# PUBLIC COMMENT

Subject: Garage placement code amendment draft language

Subject: important: proposed garage placement tool will hurt affordability

### PROPOSED GARAGE PLACEMENT CODE CHANGE WILL HAVE NEGATIVE IMPACT

Graphic from Infill Tool Pamphlet represents 70' plus wide lot.

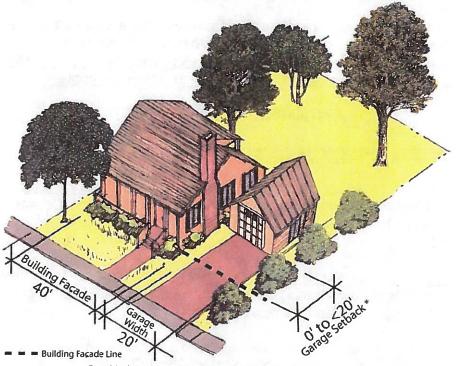
The drawing from the City of Austin's Infill Tool pamphlet was cited as an example of the intended parking arrangement on a 70' plus wide lot with a single-family detached home. While this tool *may* make sense on extra wide lots such as this (of which there are few), Austin should not apply this tool to more affordable infill sites that are not as wide.

This garage/carport placement tool works well with larger lot expensive home sites, and renders many more affordable designs in desired development zones impossible.
